Town of Amherst

40R Smart Growth Overlay District

Public Comments

as of July 7, 2020

Street level view looking south on Cottage Street toward Triangle, applying proposed by-law dimensional requirements. This is an abrupt change from established neighborhood to the T5 canyon wall, and not the "seamless transition" stated as a goal of 40R.

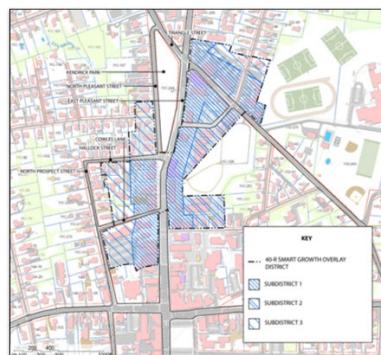
- "Transitions to Neighborhoods" is NOT what is described in these bylaws. Rather, abrupt, contextual conflicts are described in the stated setbacks and height allowances in Dimensional Requirements. See sketch below.

- Underlying Limited Business (B-L) Zoning Districts must still play a role in any consideration of massing and scale for new construction. The B-L district must continue to buffer the abutting and surrounding neighborhoods from exactly what is being proposed: 4/5-story, curbside construction! See sketch below.

- Zero (0') minimum front and side setbacks are absolutely contrary to the neighborhood and Town Center character. No protections are offered to abutters for loss of sunlight and privacy. Existing applications of 5-story, curbside construction at Kendrick Place and 1 East Pleasant portend equally unacceptable, future outcomes per these proposed bylaws.

| T5 proposed for Lower Cottage Street (now a B-L district)

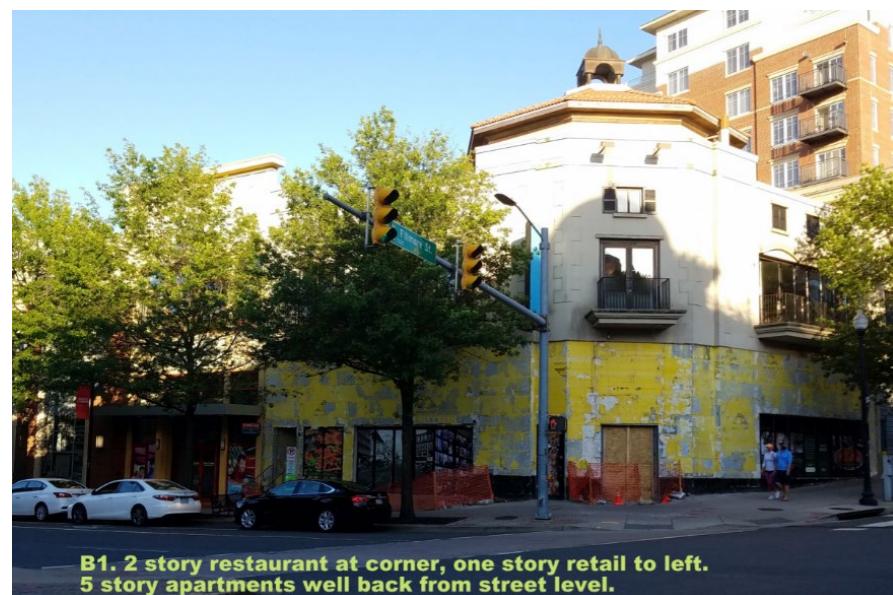
- Designating the entire B-L district as Urban Center T5 is unacceptable.
 - There is ZERO transition from neighborhood to T5; there is absolutely NOTHING that protects, or responds to, or reflects “surrounding neighborhood character”! (see sketch below)

- Does not define relationship with Cottage Street neighborhood.
 - c. “Vertical articulation of facades at regular interval to echo scale of existing architecture” is absolutely NOT in evidence – see sketch of Cottage Street.
